**RE: Pitt Town Residential Precinct (Concept Plan) – Preferred Project Report  
MP 07\_0140**

# **Pitt Town Residential Precinct Concept Plan**

## **Preferred Project Report**

**Department of Planning Reference  
MP 07\_0140**

# PITT TOWN MASTERPLAN

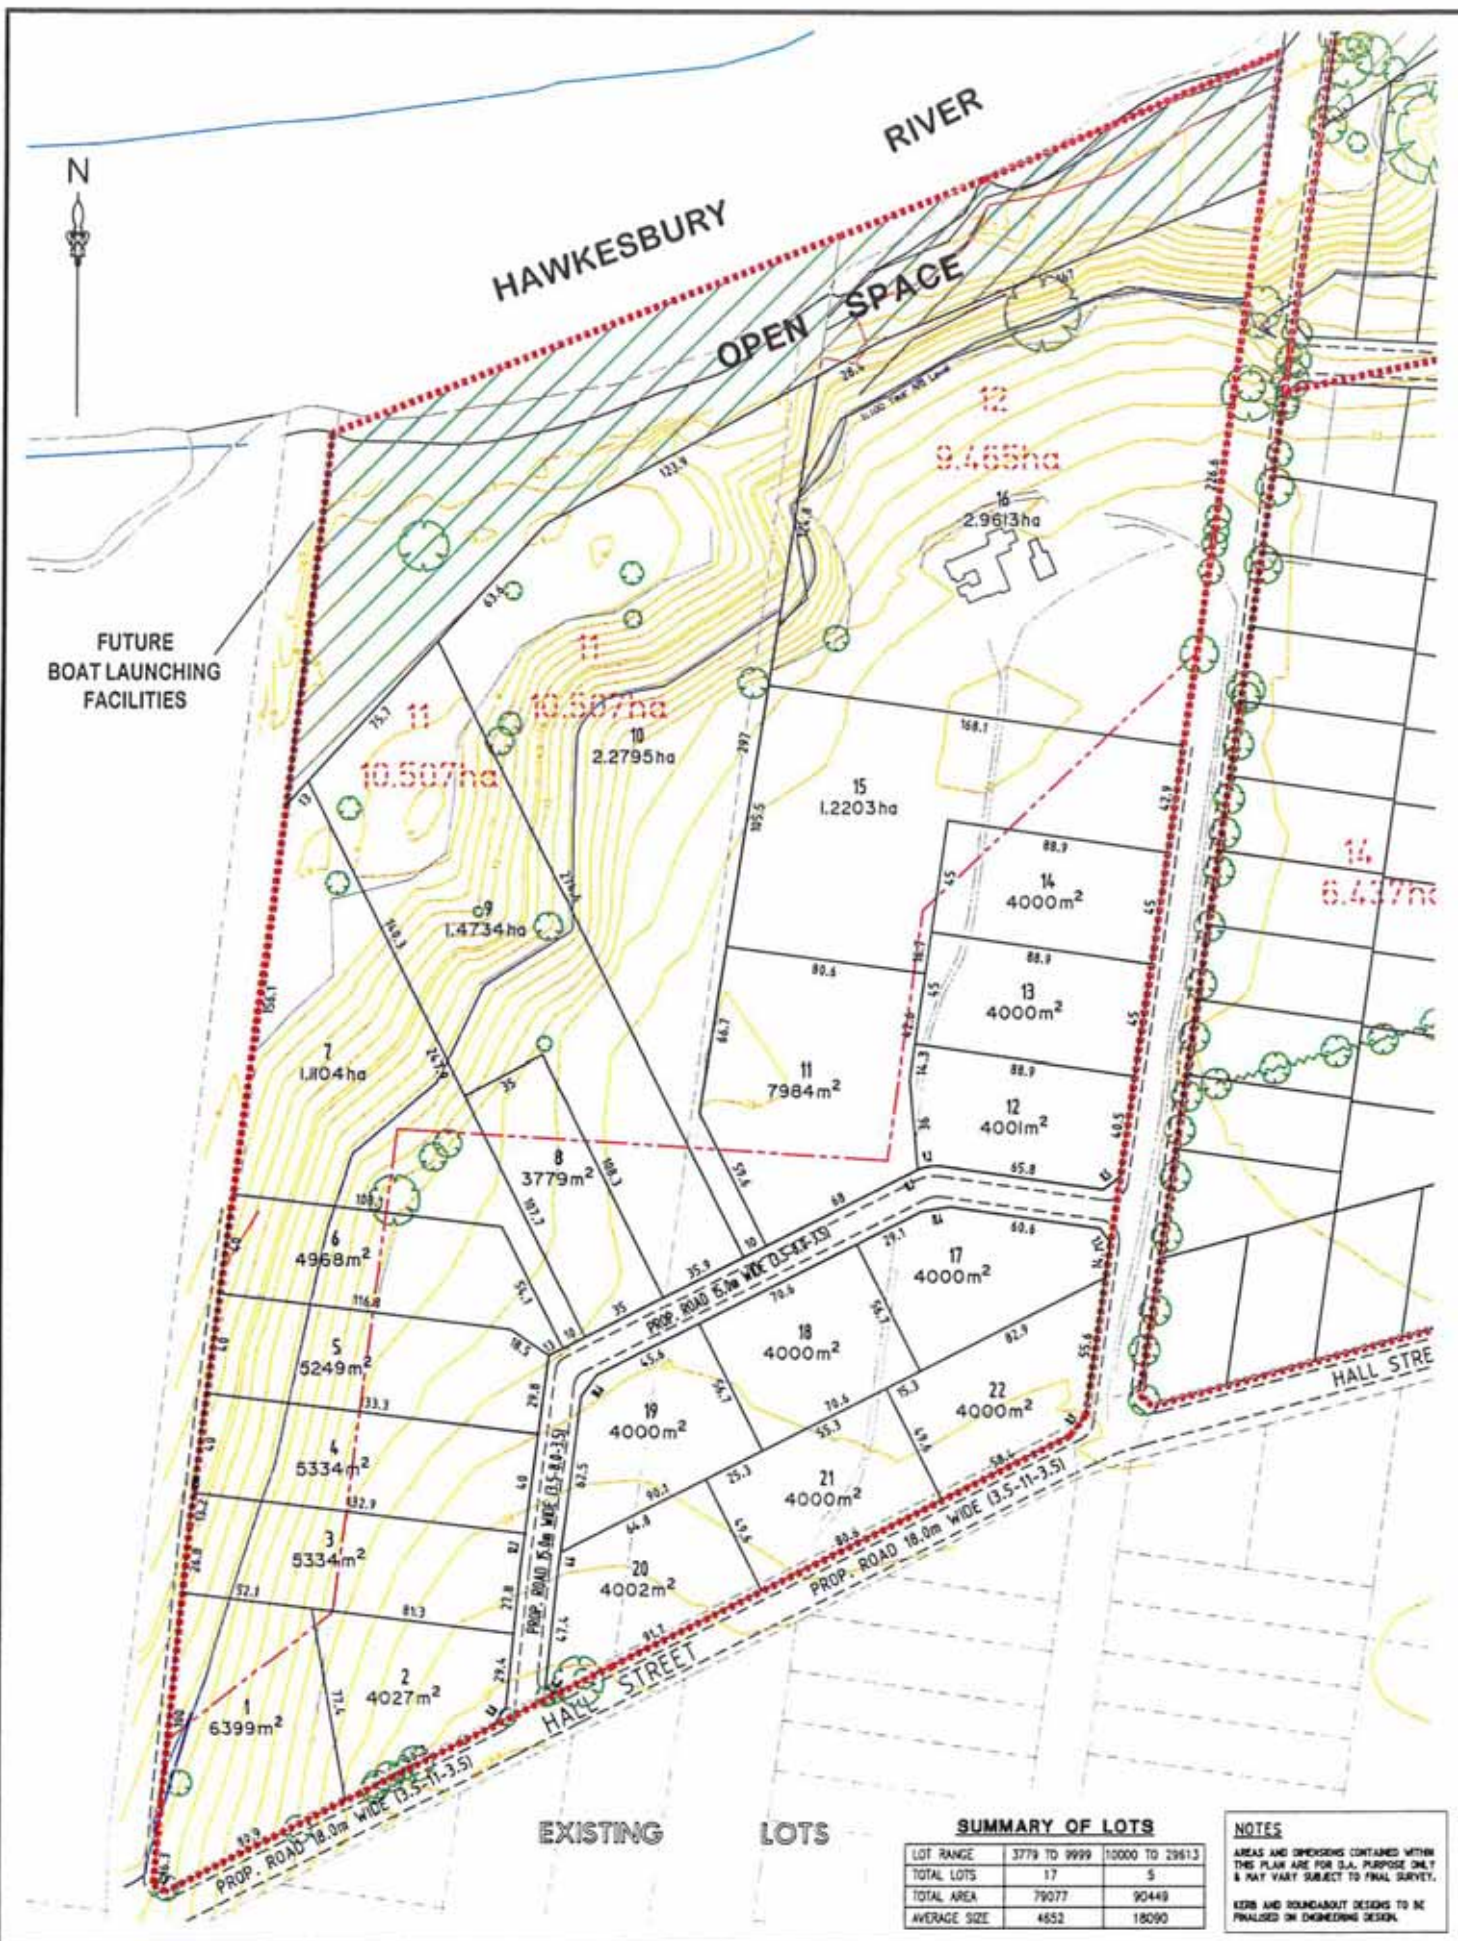
<b>Fisheries</b>				
Minimising impacts on the riparian zone DPI	Open space will be provided along the River frontage (although the open space will not be as deep as originally proposed – see comments under the heading Open space below. No additional riparian rights will be created.	The proposal is considered to adequately address this issue	No	No
<b>Open space</b>				
Management of Blighton Riverside Park HCC	<p>In response to the submission by Hawkesbury City Council, the Concept Plan has been modified to reduce the size of the Blighton Riverside Park. To maintain the required riparian buffer to the Hawkesbury River the open space will be a minimum width of 45 metres. The northern lots in Cleary and Thornton Precincts have been extended such that the large area of open space proposed in the exhibited plan, including the detention basin in Thornton Precinct, will be retained in private ownership.</p> <p>The amended plan is attached as <b>Attachment F</b>. Upon Concept Plan and rezoning approval, JPG</p>	The layout plan has been amended – refer to the plan attached as <b>Attachment F</b> .	No	Yes

REVISED 25th March 2008
